CALL NO. 100
CONTRACT ID NO. 241306
ADDENDUM # 1

Subject: Breathitt County, NHPP 0151 (090)
Letting March 21, 2024

- (1) Added - Traffic Management Plan - Pages 583A-583L of 649
- (2) Revised - Plan Sheets U-039, U-041, U-042, U-044, U-045, U-047

Sheet No.	U-039
City of Jackson - Utility Relocation	BREATHITT COUNTY, KY - KY15, ITEM NO. 376.00
Date	2023-08-17
Drawn By	JCM
Scale	AS SHOWN
Job No.	933.40

CITY OF JACKSON
 UTILITY RELOCATION
 BREATHITT COUNTY, KY - KY15
 ITEM NO. 10-376.00
 BUS GARAGE LIFT STATION DETAILS

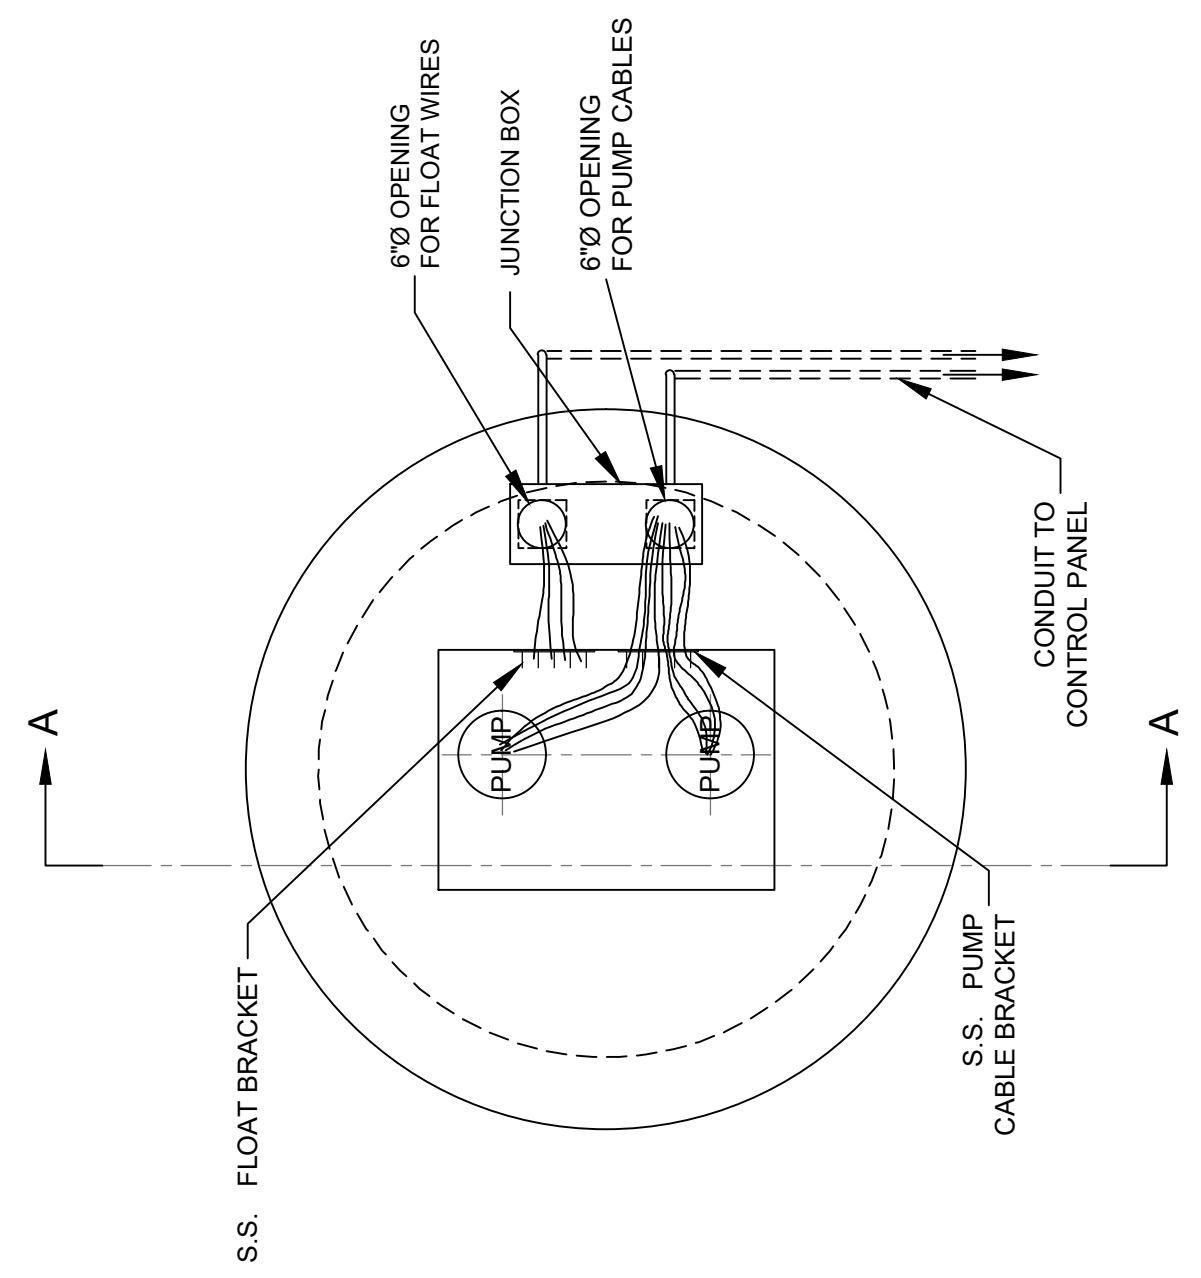
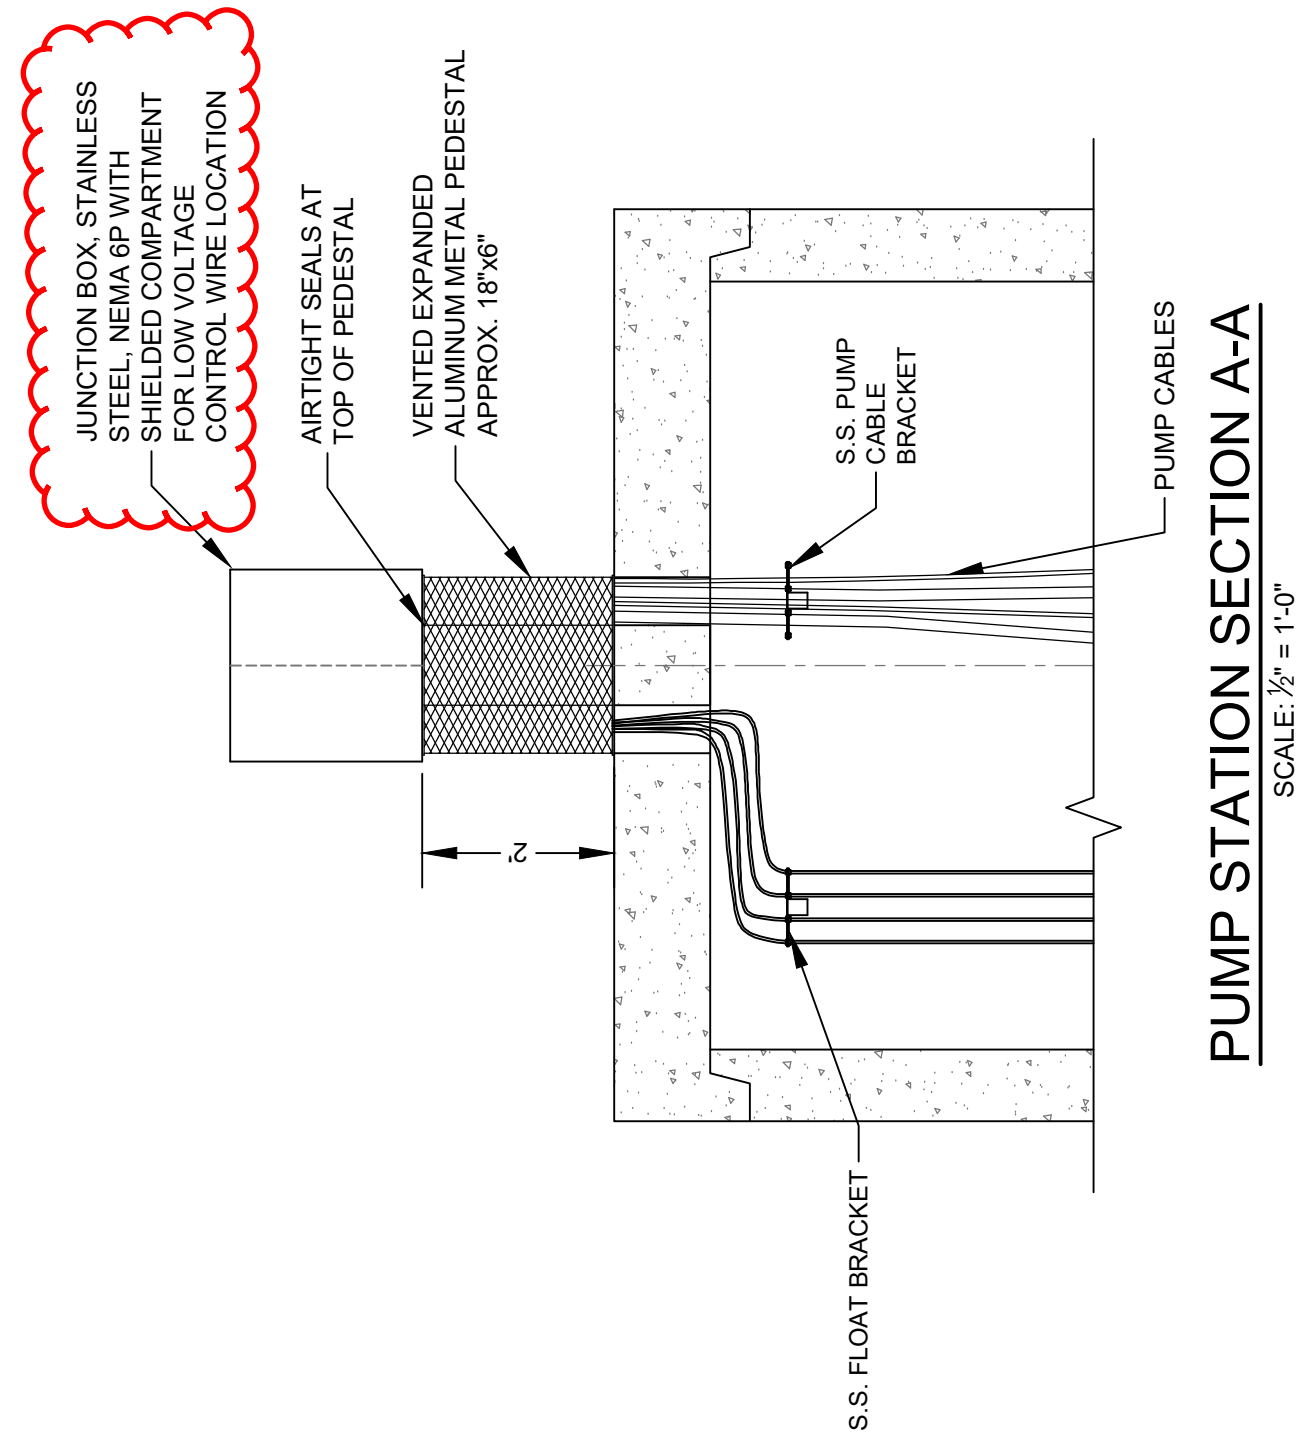
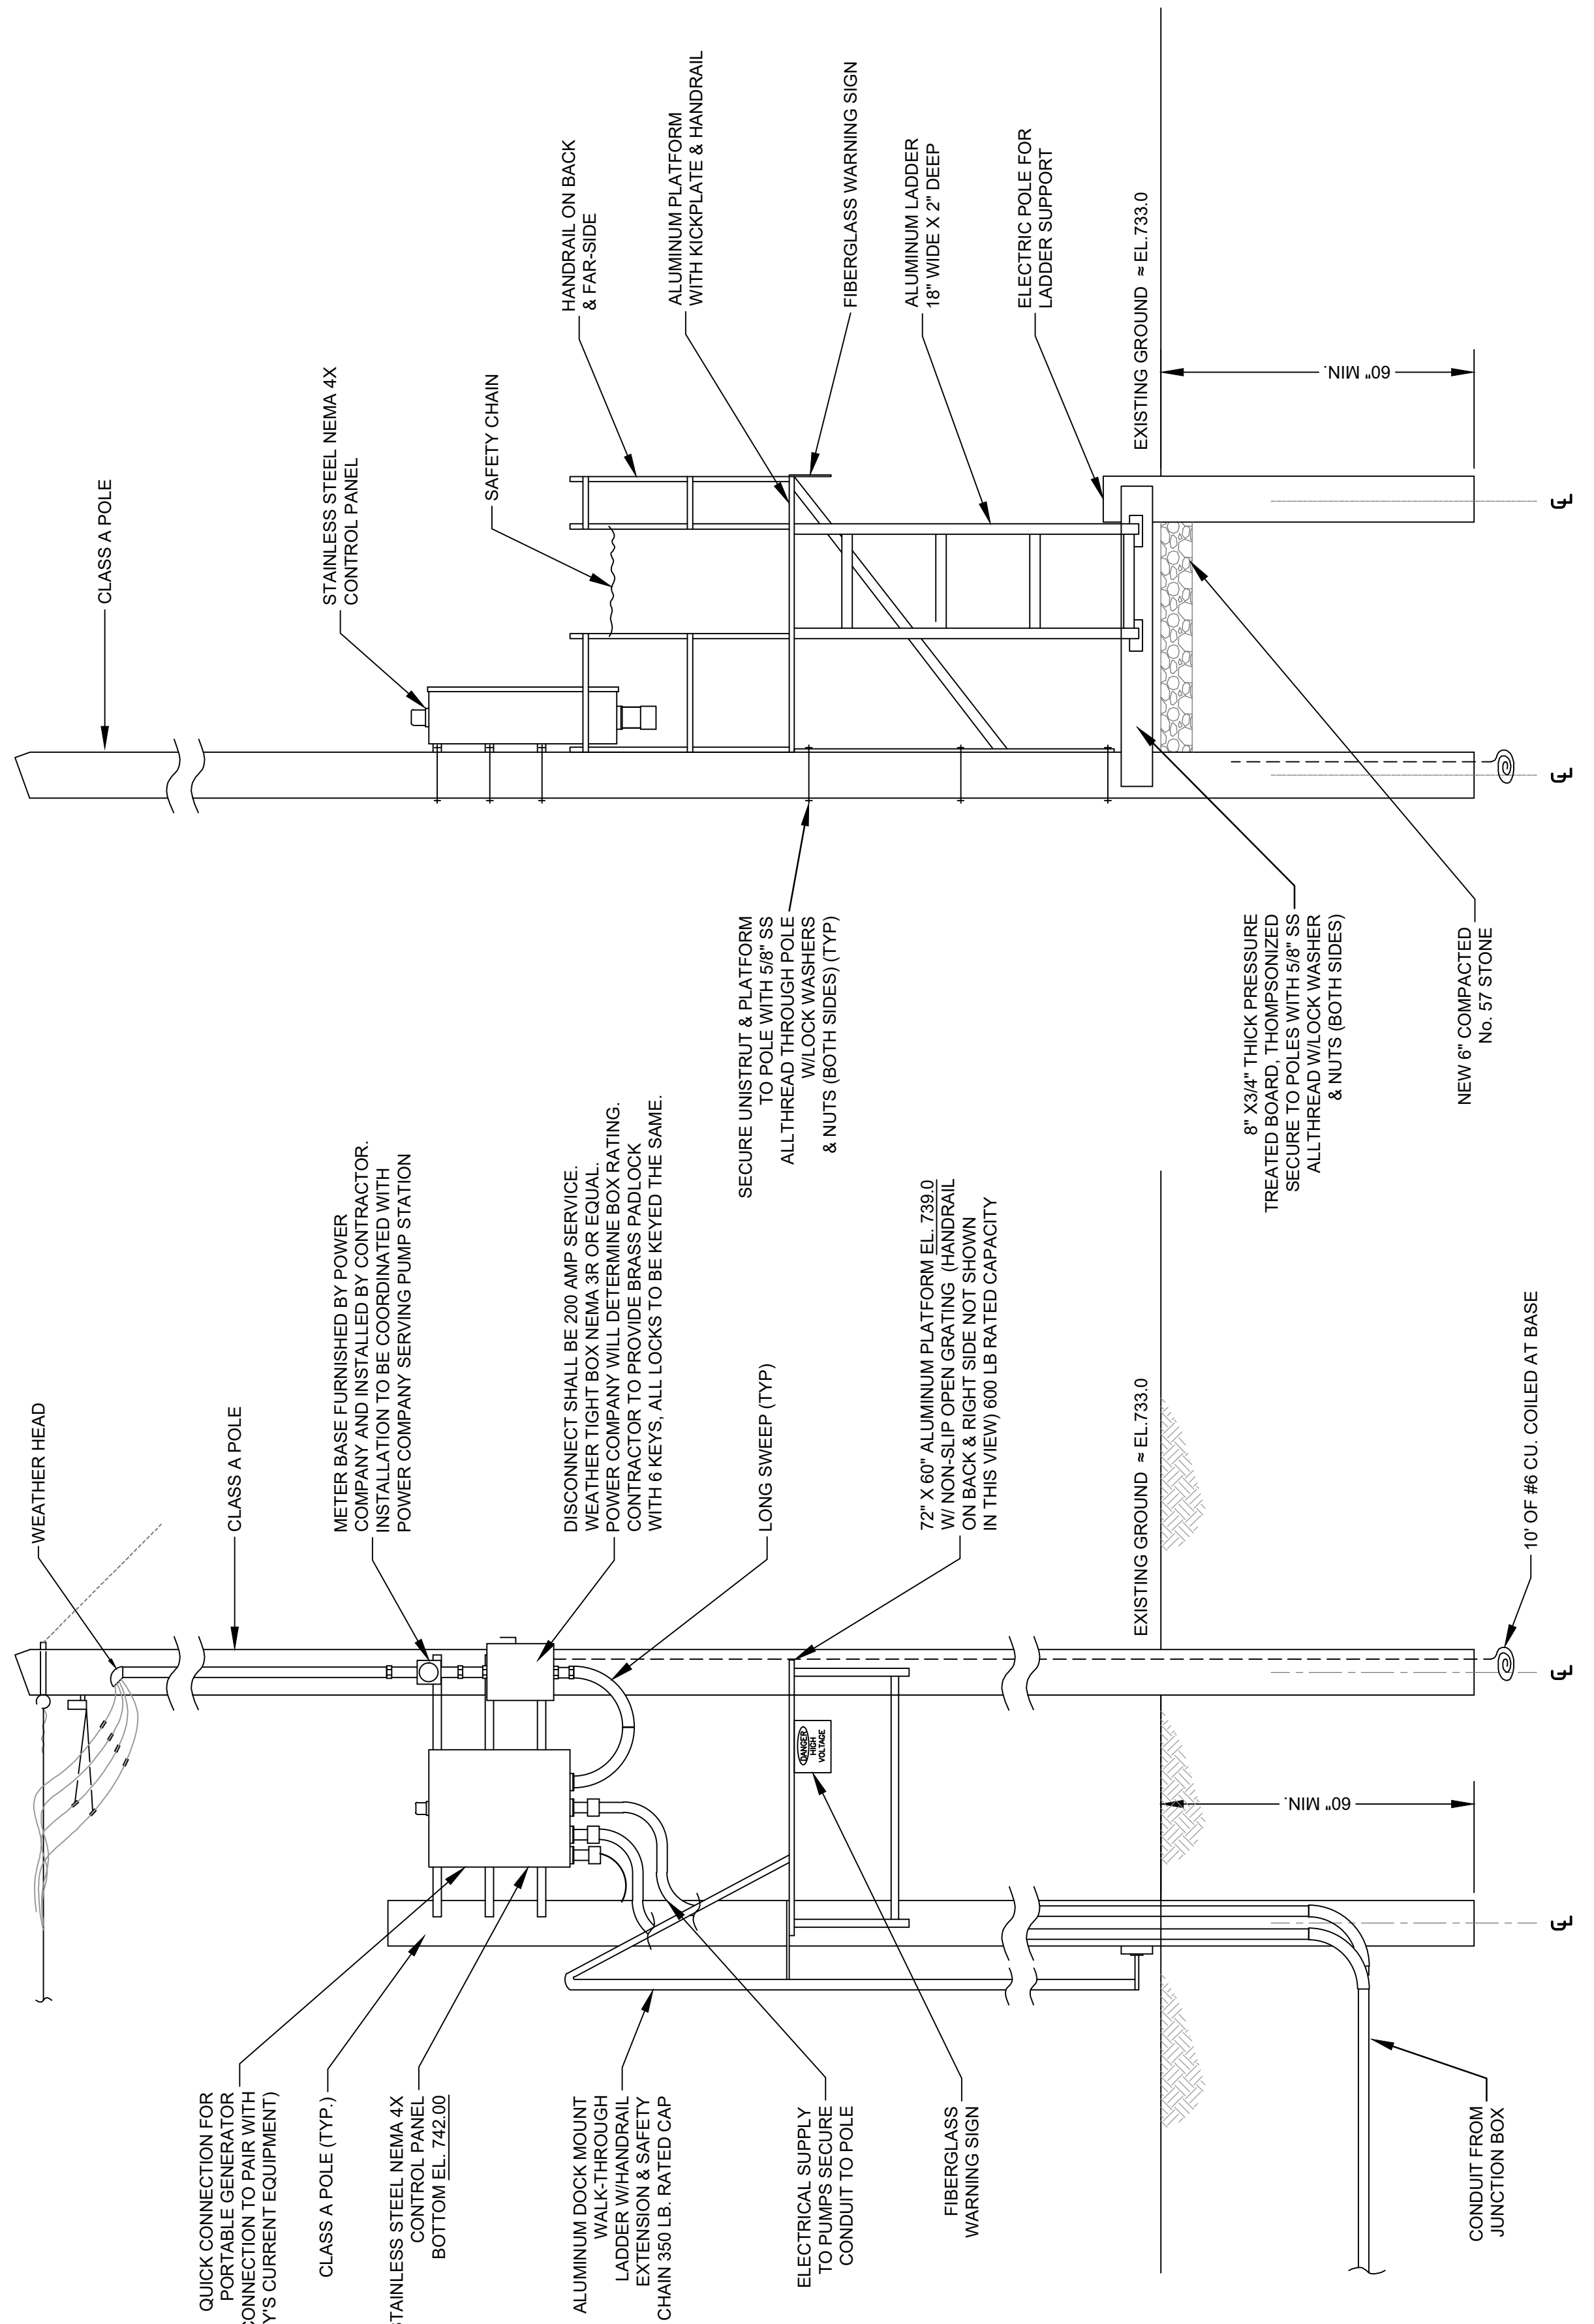
2024-02-20 ADD1 CHANGE JUNCTION BOX TO 6P
